UNITED STATES PATENT AND TRADEMARK OFFICE

APPLICATION NO.	FILING DATE	FIRST NAMED INVENTOR	ATTORNEY DOCKET NO.	CONFIRMATION NO.
10/762,021	01/20/2004	Jong Cheol Jang	GRANP3.003AUS	3989
20995	7590	11/23/2004	EXAMINER	
KNOBBE MARTENS OLSON & BEAR LLP			WELCH, GARY L	
2040 MAIN STREET			ART UNIT	
FOURTEENTH FLOOR			PAPER NUMBER	
IRVINE, CA 92614			3765

Office Action Summary	Application No. 10/762,021	Applicant(s) JANG, JONG CHEOL	
	Examiner Gary L. Welch	Art Unit 3765

DETAILED ACTION

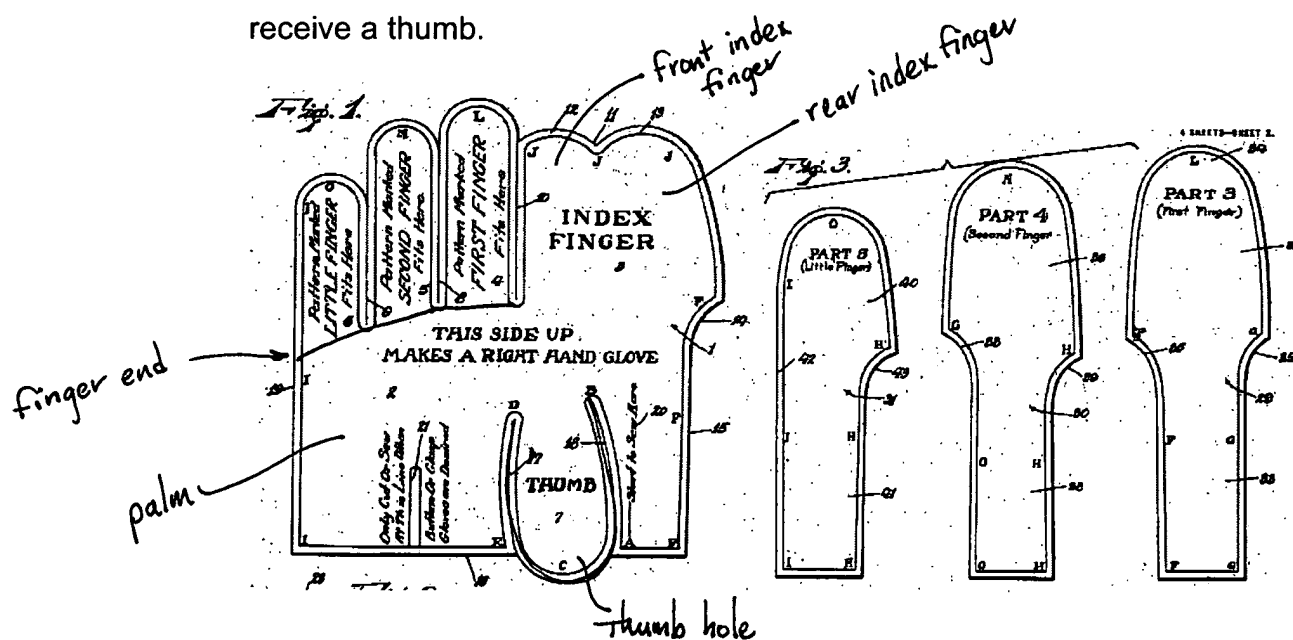
7. Claims 1-8 are rejected under 35 U.S.C. 102(b) as being anticipated by Ruddell (U.S. 1,427,419).

Ruddell discloses a five-fingered, comprising:

a palm piece having a front index finger portion, a rear index finger portion, a finger end and a thumbhole, wherein the front and rear index finger portions are integrally formed; a backhand piece (Figure 3), having a rear middle finger portion, a rear third finger portion and a rear little finger portion which are integrally formed, coupled to the rear index finger portion of the palm piece; a finger piece, having a front middle finger portion, a front third finger portion and a front little finger portion which are integrally formed, coupled to the finger end of the palm piece, wherein the front and rear index finger portions are together configured to receive an index finger, wherein the front and rear middle finger portions are together configured to receive a middle finger, wherein the front and rear third finger portions are together configured to receive a third finger, and wherein the front and rear little finger portions are together configured to receive a little finger; and a thumb piece coupled to the thumbhole of the palm piece and configured to receive a thumb.

With regard to claim 4, as best understood, the finger end of the palm piece is positioned upward to the front index finger portion with a cutting line of the finger piece moved inward so as to make the length of the finger portions shortened (see above Figure).
